WISDOM INDUSTRIES, INC

## COASTER BULLETIN

DATE: AUGUST 1995  
RIDE: LARGE DRAGON  
SUBJECT: PIVOT AXLE FRAME

# SAFETY BULLETIN

<b>WISDOM INDUSTRIES</b> Merino, CO 80741	
SCALE: 1 1/2" = 1' - 0"	APPROVED BY:
DATE: 08-28-95	DRAWN BY: MFK
DESCRIPTION	
<b>AXLE INSPECTION</b>	
EQUIPMENT:	DRAWING NUMBER
<b>CHINA DRAGON</b>	<b>3CD-01</b>

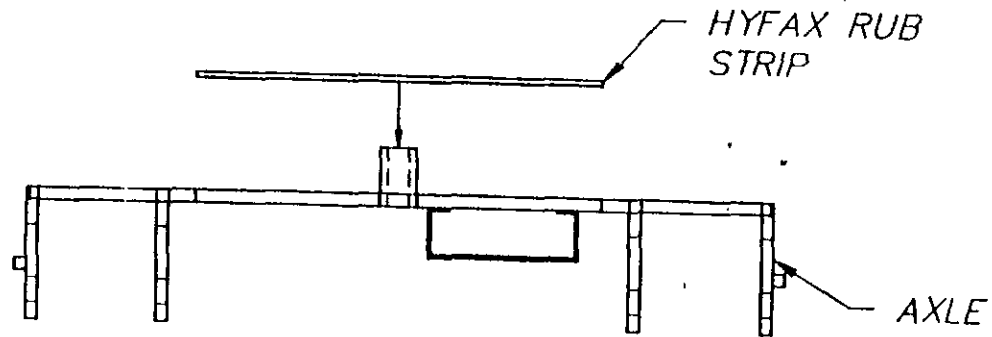
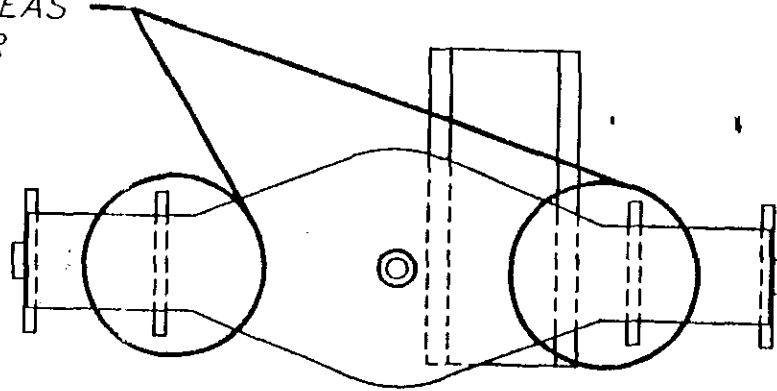
It has come to our attention that cracks have developed on one Orient Express pivot axle frame. Please use the enclosed drawing as a guideline for inspecting pivot axle frames for cracks. If cracks are noted, contact us immediately for instructions on replacement or repair.

We are currently requiring that all pivot axle frames be replaced with a new style. **Daily inspection of these pivot frames are required until they are replaced.**

INSPECT THESE AREAS  
ON ALL AXLES FOR  
CRACKING.

1. Roll train off trailer to where frame can be seen from underneath.
2. Inspect areas called out in drawing.
3. **If cracks are noted, remove axle for repair or replacement before operating ride.**

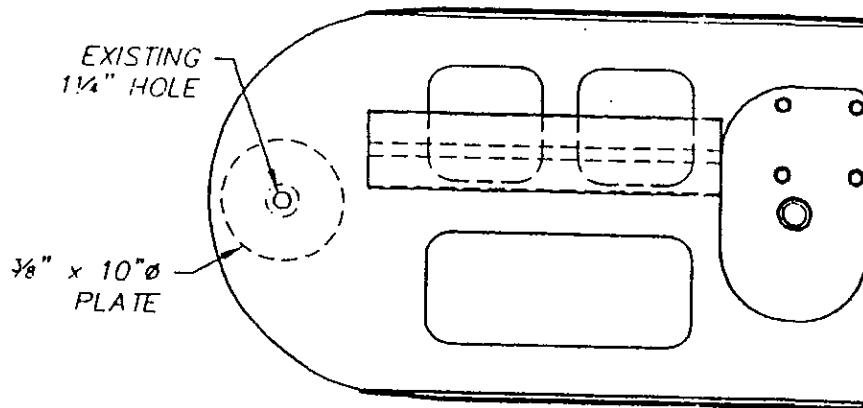
Due to the high wear on the front axle pivot ball, we are requiring that all ball type front pivot axles be replaced with a new style. Please use the enclosed drawing as a guideline for installing the new front pivot axle.

1. Roll train off trailer to where front axle & ball can be seen from underneath.
2. Inspect the area around the neck of the ball for wear.
3. If the neck of the ball is worn down to less than 3/4" across, replace the ball before operating the ride.
4. If the neck area is larger than 3/4", lubricate the retaining fingers with grease and return to service.

FRONT AXLE INSTALLATION

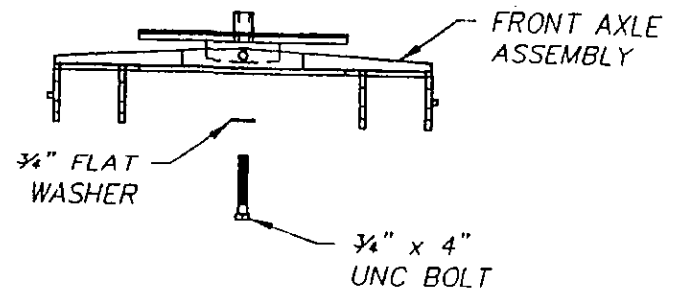
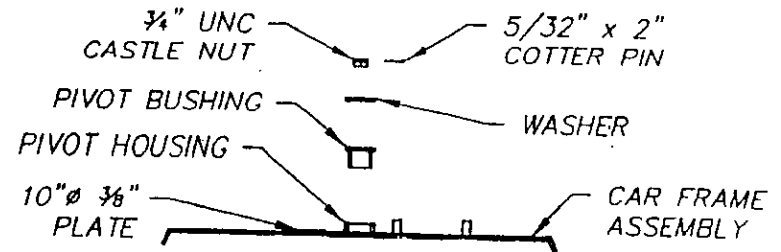
1. REMOVE FIBERGLASS CAR BODY.
2. WELD 10"Ø(3/8" PLATE) TO TOP OF CAR FRAME.
3. TORCH THE EXISTING 1 1/4"Ø HOLE OUT TO 2 3/4"Ø HOLE.
4. WELD PIVOT HOUSING FLUSH WITH BOTTOM OF CAR FRAME.
5. LET AREA COOL.
6. PUT PIVOT BUSHING IN (ON TOP OF CAR FRAME).
7. TRIM FIBERGLASS CAR BODY TO FIT.
8. REINSTALL FIBERGLASS CAR BODY.
9. INSTALL FRONT AXLE (SAME PROCESS AS REAR AXLES).

<b>WISDOM INDUSTRIES</b> Merino, CO 80741		
SCALE: NTS	APPROVED BY: <i>mtg/mtw</i>	DRAWN BY: JJR
DATE: 12-14-00		REVISED
DESCRIPTION CAR HITCH MODIFICATION		
EQUIPMENT: COASTERS	DRAWING NUMBER HITCH MOD

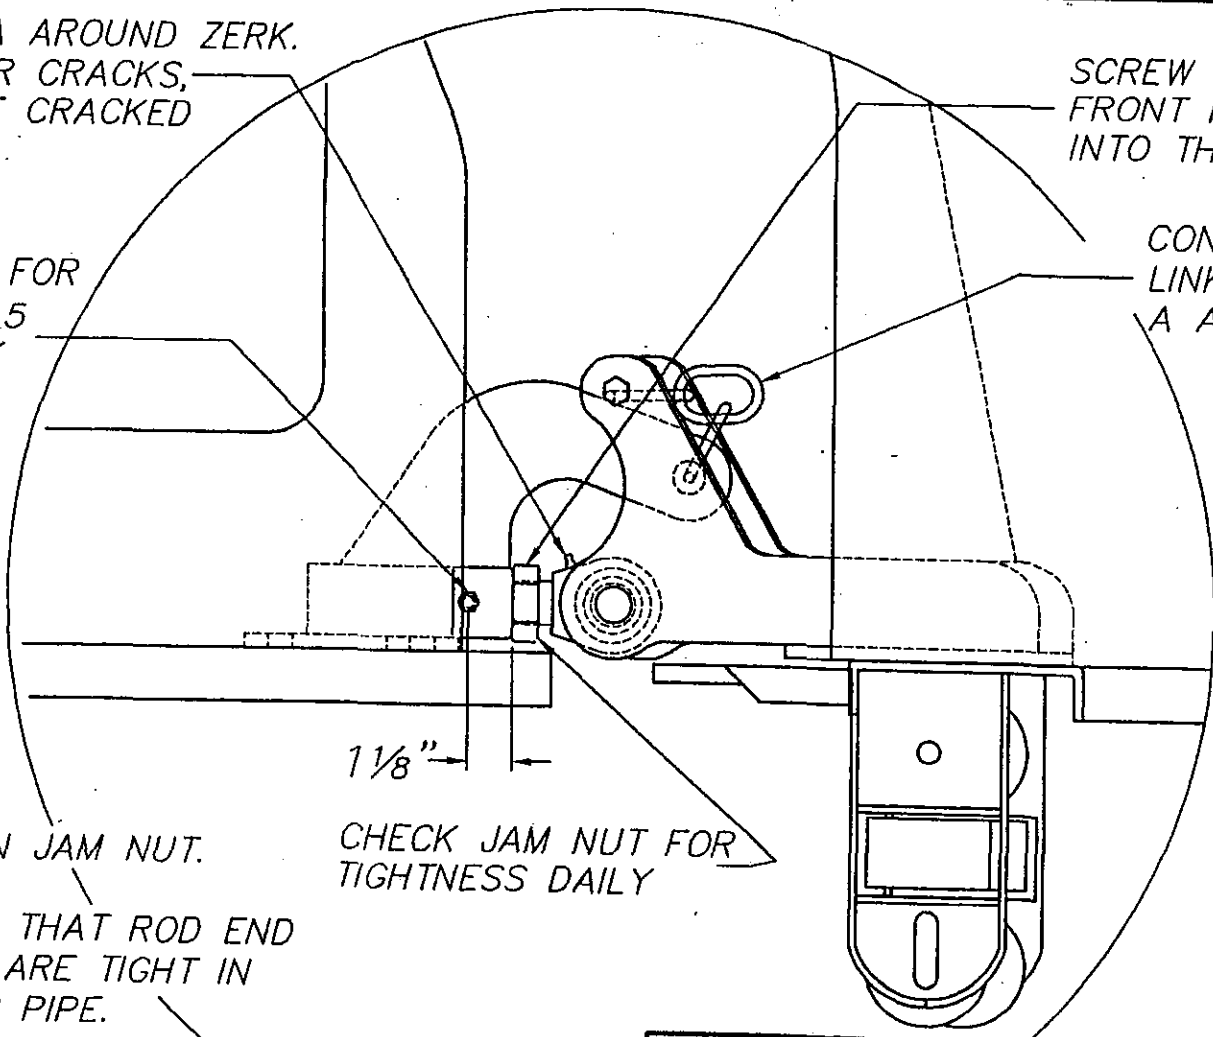
11. Measure  $1 \frac{1}{8}$ " from where jam nut touches front hitch threaded mount. (See Drawing)
12. Cross drill threaded coupler mount for a  $\frac{5}{16}$ " bolt.
13. Install a  $\frac{5}{16}$  X 3" grade 5 bolt and lock nut and tighten.
14. Repeat for other rodends.

CLEAN AREA AROUND ZERK.  
INSPECT FOR CRACKS,  
REPLACE OF CRACKED

SCREW ROD END INTO  
FRONT HITCH COMPLETELY  
INTO THREADED HOUSING.

CROSS DRILL FOR  
5/16 GRADE 5  
BOLT & LOCK  
NUT.

1 1/8"

1. LOOSEN JAM NUT.
2. CHECK THAT ROD END  
THREADS ARE TIGHT IN  
MOUNTING PIPE.
3. TIGHTEN JAM NUT.

<b>WISDOM INDUSTRIES</b> Merino, CO 80741		
SCALE: NTS	APPROVED BY: 	DRAWN BY: JJR
DATE: 12-14-00		REVISED
DESCRIPTION		
CAR HITCH		
EQUIPMENT:		DRAWING NUMBER
COASTERS		HITCH MOD 1

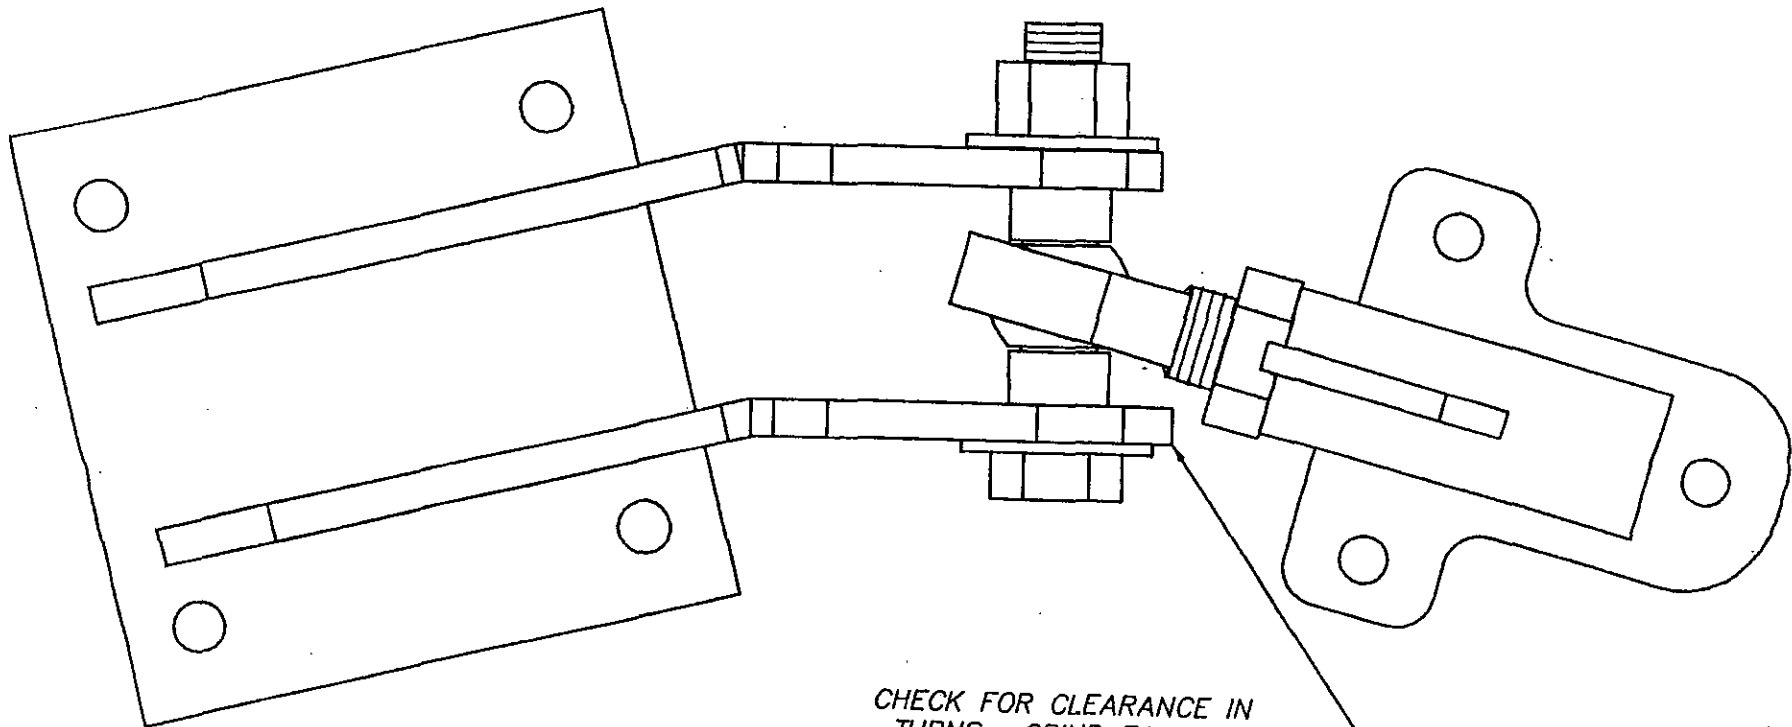
CHECK JAM NUT FOR  
TIGHTNESS DAILY

CHECK FOR CLEARANCE IN  
 TURNS. GRIND EAR AT AN  
 ANGLE TO CLEAR ROD END  
 SHANK.
